**Re: #09ITB1005K-JD Interior Renovation 137 Peachtree Street Building**

**#09ITB1005K-JD Interior Renovation 137 Peachtree Street Building**  
**Addendum No. 4**  
**Page Two**

This Addendum forms a part of the contract documents and **modifies** the original RFP documents as noted below:

Photo #2

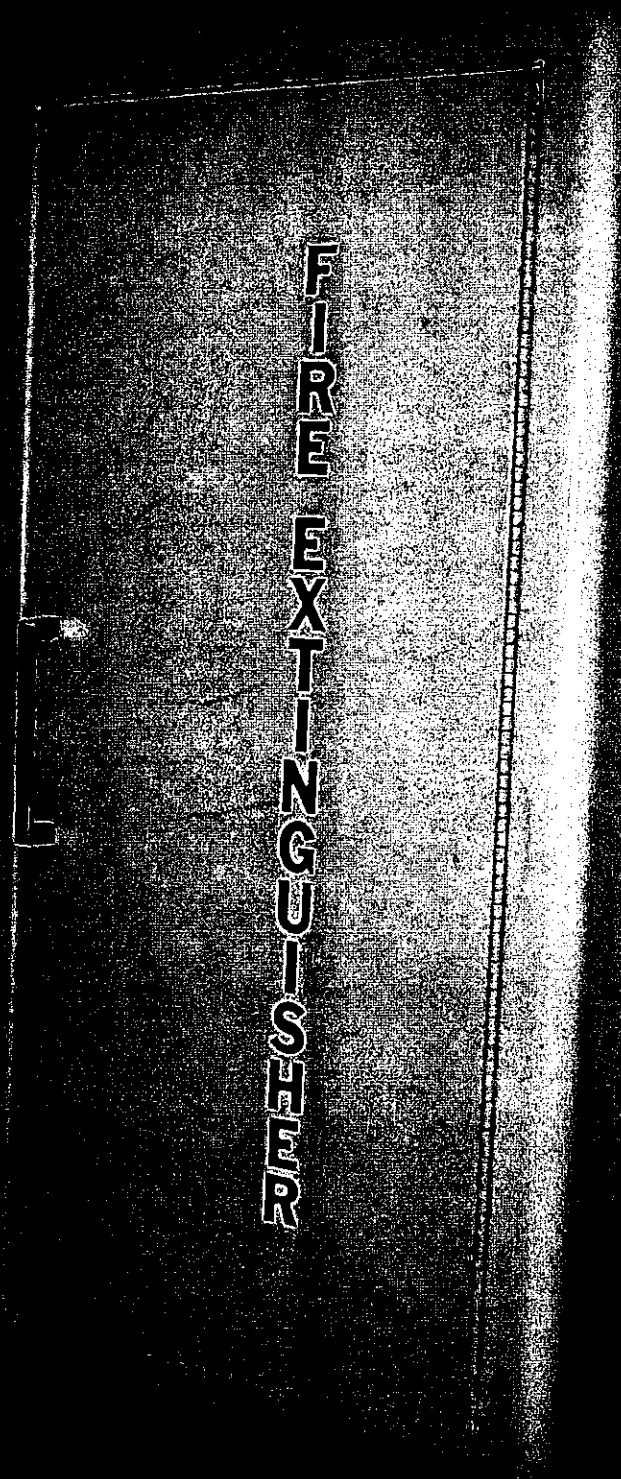
**Question:** Fire Extinguisher Cabinets-No specification for new cabinets or fire extinguisher Provide missing specification.

**Answer:** Fire Extinguisher Cabinets will match existing. See Photo #2-**SEE ATTACHMENT # 4**

SK# 3

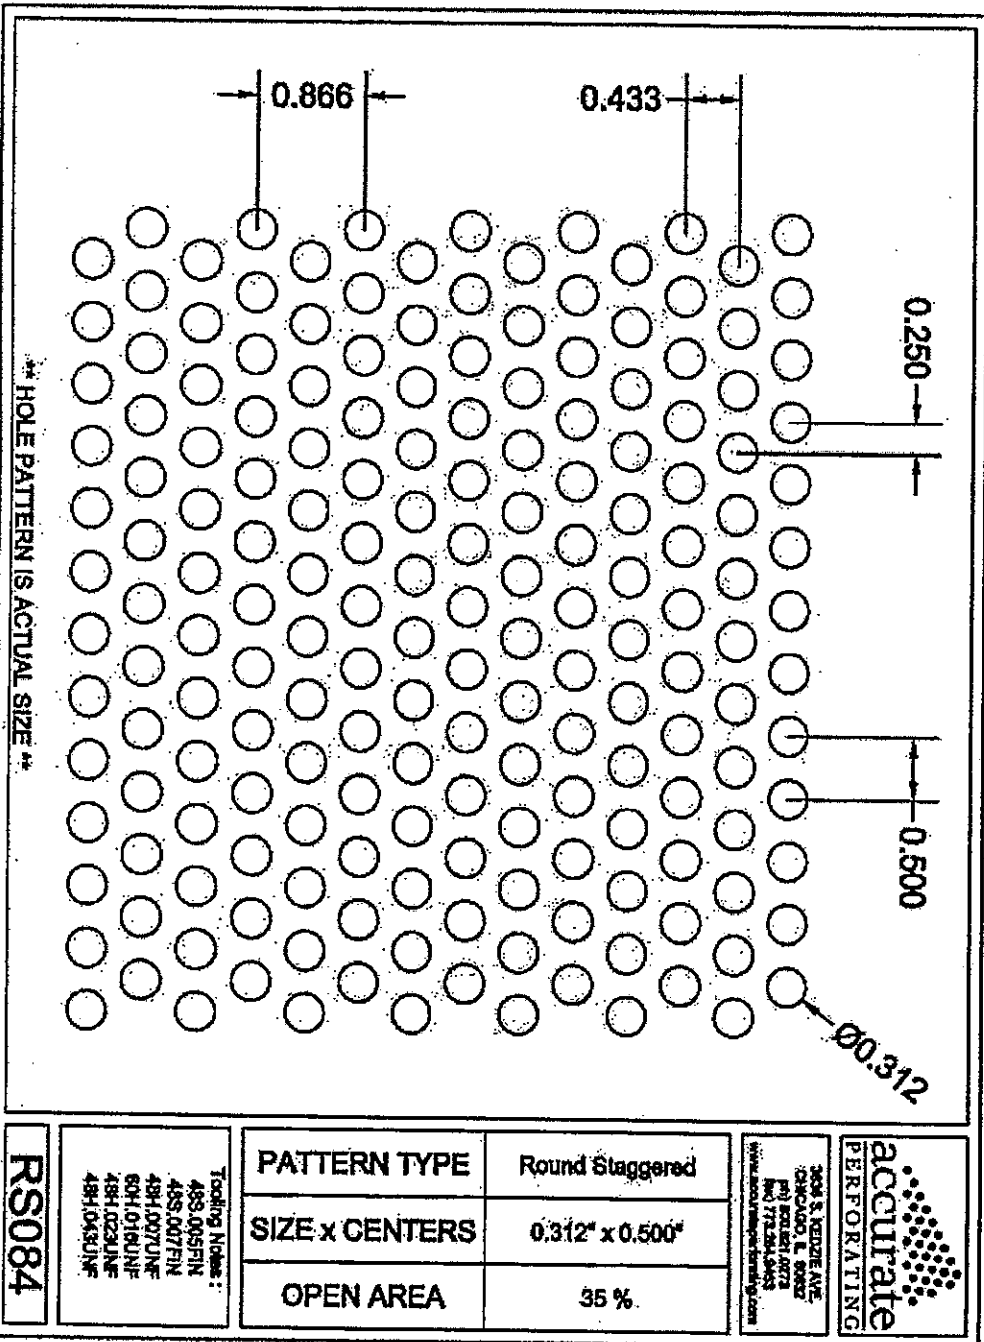
**Question:** Perforated steel-Drawing A-3.1 detail N1 & E1 indicates perforated steel in the fence design. Provide specification of material and manufacture.

**Answer:** Perforated steel sheets are to be 18 gauge powder coat painted steel, equal to Accurate Perforating Company's RS084 pattern. See SK #3-**SEE ATTACHMENT #5**
